Entergy Operations, Inc.
17265 River Road
Killona, LA 70057-3093
Tel (504)-464-3221

W3F1-2021-0057

Subject: Emergency Plan Revision 052
Waterford Steam Electric Station, Unit 3 (Waterford 3)
Docket No. 50-382
Renewed Facility Operating License No. NPF-38

Summary and Analysis of the Emergency Plan Changes
(10 CFR 50.54(Q)(3) Screening and Evaluation)

W3 SES EMERGENCY PLAN **FIGURE 2-6** **THE REGION WITHIN 10 MILES OF WATERFORD 3**

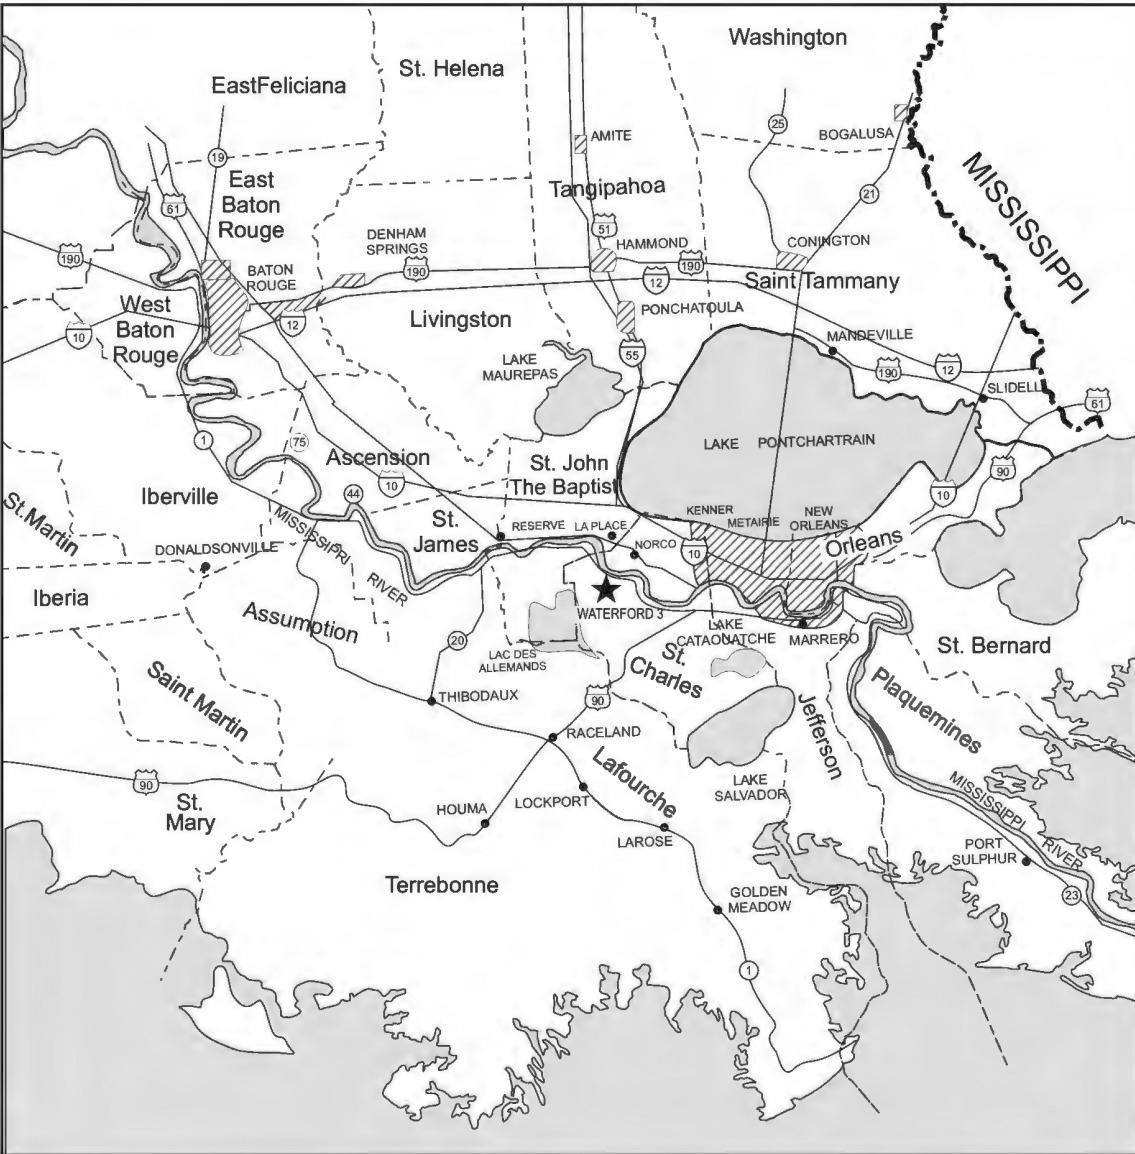
6	App. H	EN-EP-613, Recover from a Declared Emergency, 1.1.72, 3.3, 9.0	EN-EP-613, Declared Emergency Recovery and Re-Entry, 1.1.72, 3.3, 9.0
7	Section I, 1.1.61	(e.g., pocket dosimeters, direct reading electronic dosimeters, DLRs, etc.).	(e.g., pocket dosimeters, self-reading dosimeters, DLRs, etc.).
8	Figure 2-1		Changed Highway marker in Edgard from LA 3127 to LA 640
9	Figure 2-6		Changed Highway marker in Edgard from LA 3127 to LA 640

W3 SES EMERGENCY PLAN
FIGURE 5-3
NEARSITE EMERGENCY ORGANIZATION

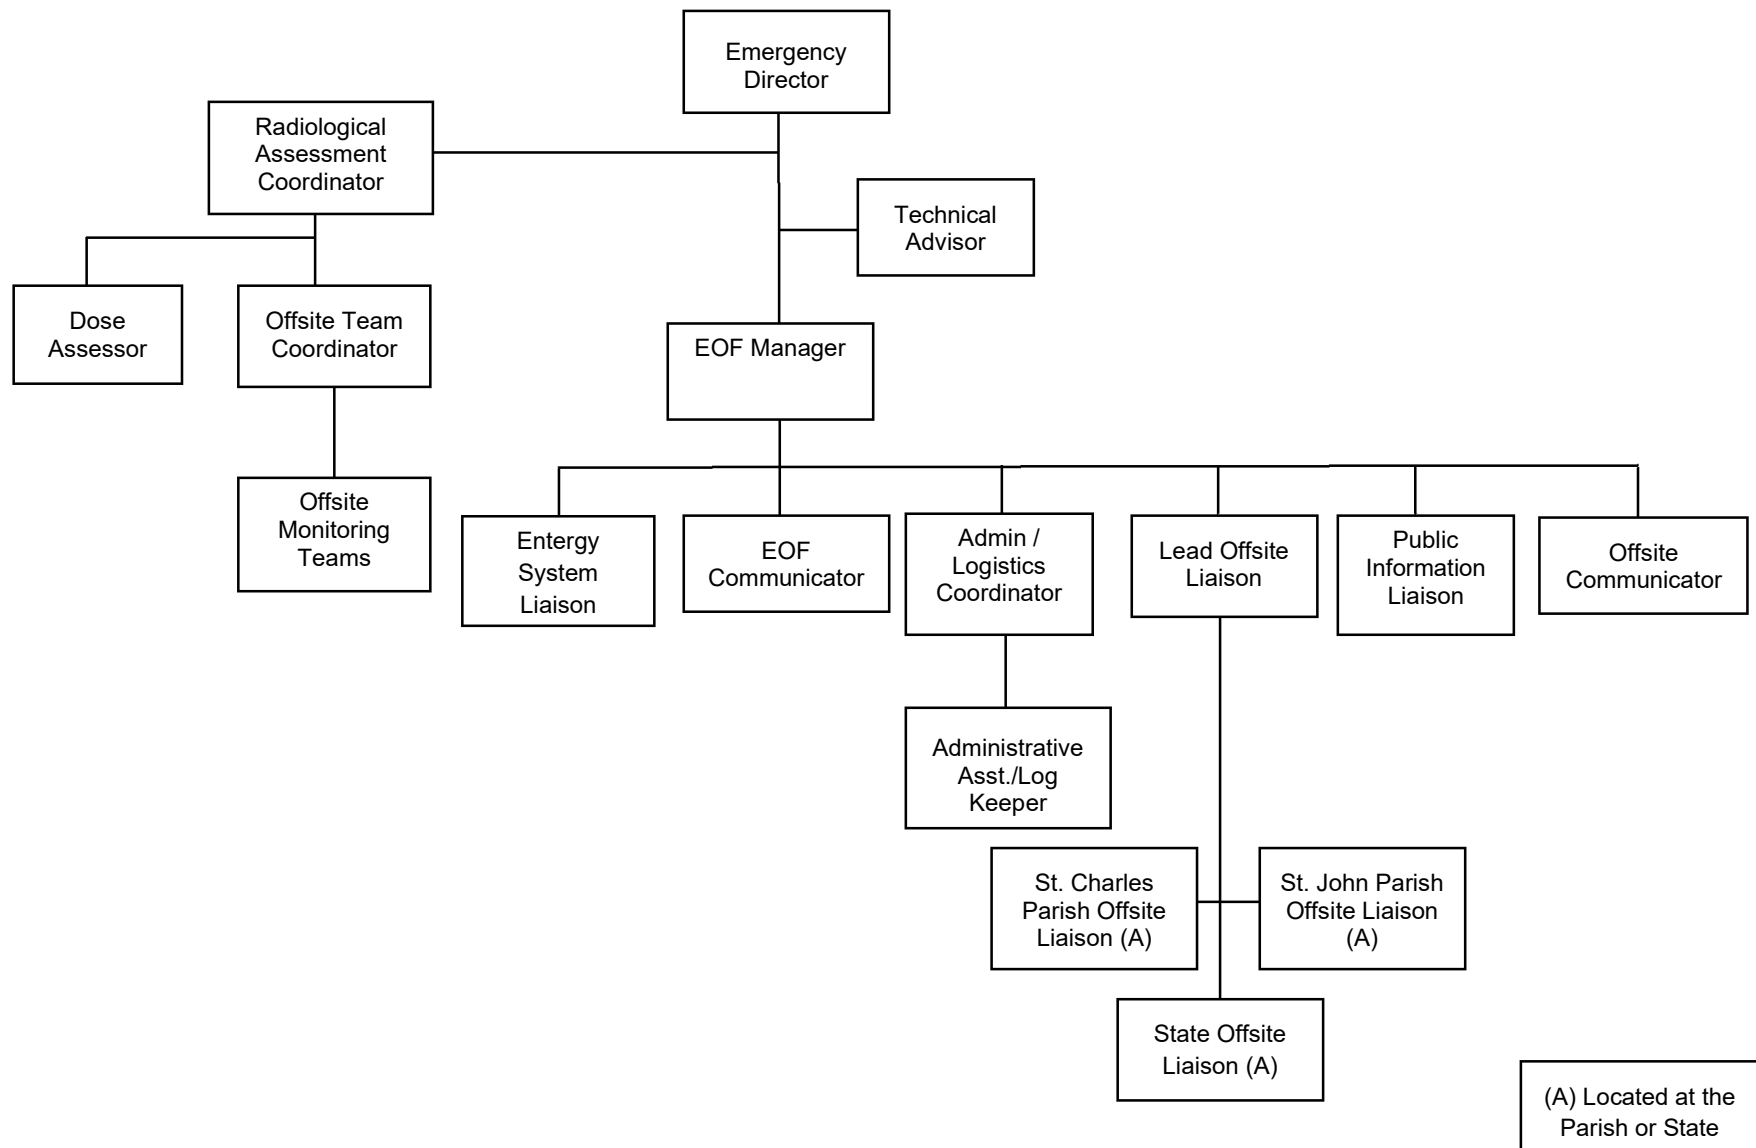
20	Figure 5-3		
21	Figure 5-5	(C) ST JOHN THE BAPTIST PARISH CIVIL DEFENSE/SHERIFF	(C) ST JOHN THE BAPTIST EMERGENCY PREPAREDNESS/SHERIFF
22	Table 5-1	Remote Shutdown Operator, CR, 1(b)*, --	Switchgear Operator, CR, 1(b)*, --
23	Table 5-1 Footnote	*THE ADDITION OF THE REMOTE SHUTDOWN OPERATORS TO MINIMUM STAFFING IS EFFECTIVE ON JANUARY 18, 2013	Deleted Footnote
24	Table 5-4	REMOTE SHUTDOWN OPERATOR+	SWITCHGEAR OPERATOR
25	Table 5-4 Footnote	THE CONTROL ROOM (SHIFT) RESPONSIBILITIES WERE REVISED TO SATISFY THE REQUIREMENTS OF THE ON-SHIFT ERO STAFFING ANALYSIS CONDUCTED IN ACCORDANCE WITH NEI 10-05 AND REQUIRED BY 10CFR50 APPENDIX E, SECTION IV.A AS DOCUMENTED IN THE WATERFORD 3 STATION ON-SHIFT STAFFING ANALYSIS FINAL REPORT REVISION 0 DECEMBER 2012.	Deleted Footnote
26	Figure 7-3		Changed Highway marker in Edgard from LA 3127 to LA 640
27	5.3.2.1	LDEQ receives notification of an emergency directly from Waterford 3 via the operational hotline. During non-office hours, LDEQ maintains a duty officer system. The LDEQ duty officer is notified of an emergency through the Governor's Office of Homeland Security & Emergency Preparedness.	LDEQ receives notification of an emergency directly from Waterford 3 via the operational hotline. During non-office hours, LDEQ maintains a duty officer system. The LDEQ duty officer is notified of an emergency through the State Police Dispatch Center.
